Comments from Japan to the document by Dr. Henry Holroyd on November 16th 2022

Committee for standardization of HFCV, Japan

January 25th, 2023

Table 3. Summary of the test results for the specimens No. 4-18

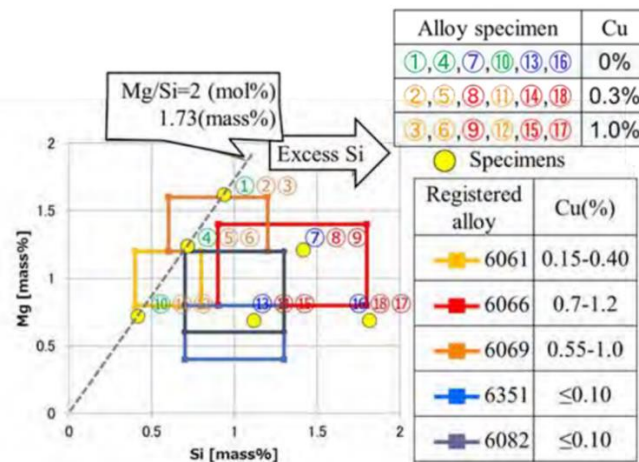
- 1 The actual  $K_{IAPP}$  values ( $K$  value to be applied during HG-SCC test) for the testing of fourteen Al-Mg-Si alloys (26 test pieces) including industrially produced 6061 alloy with T6 temper are ranging from 14.3 to 19.6  $\text{MPa}\sqrt{\text{m}}$  [Itoh et al.: 2020] far below 85% (25.5  $\text{MPa}\sqrt{\text{m}}$ ) of the typical  $K_{IC}$  value (30  $\text{MPa}\sqrt{\text{m}}$ ) Dr. Holroyd quoted.
